Gearcase Failures – 90/120 HP

1995, 1996 and 1997 Force 90/120 HP Models, serial number

0E093700 thru 0E287999

Shift Cable Installation

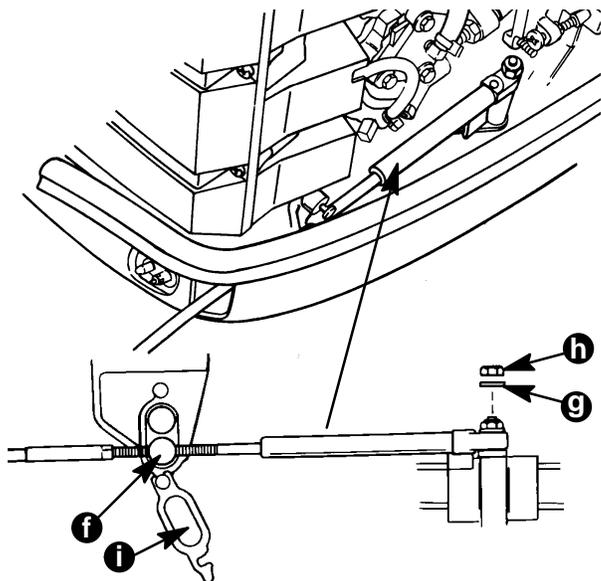
Shift cable installation is critical to ensure gearcase durability.

1. Position the remote control and outboard into neutral.
2. Slide shift actuator (a) toward the rear of engine (reverse gear) until resistance is felt. Measure distance (b) between mounting stud (c) and barrel retainer (d).
3. Push the cable end (e) in (towards cable barrel) until resistance is felt. Adjust the cable barrel (f) to attain distance (b).

- Place cable barrel (f) into retainer and close latch (i). Fasten the cable end to mounting stud with nylon washer (g) and locknut (h). Tighten locknut against the nylon washer, then back-off the locknut 1/4 turn.

Gearhousing Assembly Identification

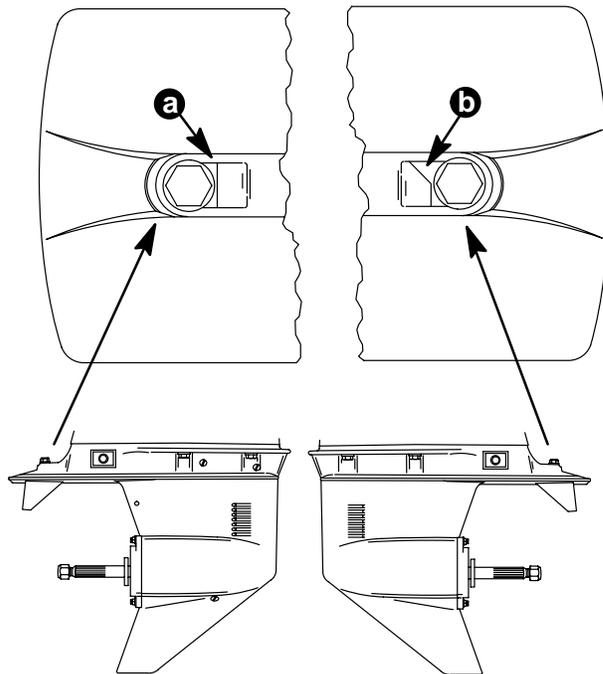
Identify gear case design to ensure correct components are being installed. Design I - "3 Jaw Reverse Clutch" (a) gear case identified with straight machined edge for trim tab screw mounting surface. Design II - "6 Jaw Reverse Clutch" (b) gear case identified with angled machined edge for trim tab screw mounting surface.

After the "6-Jaw Reverse Clutch" gearcase and updated Shift Shaft have been installed replacement parts **MUST** be ordered from the 1998 model year parts list. "3-Jaw" and "6-Jaw" reverse clutch parts are **NOT** interchangeable.
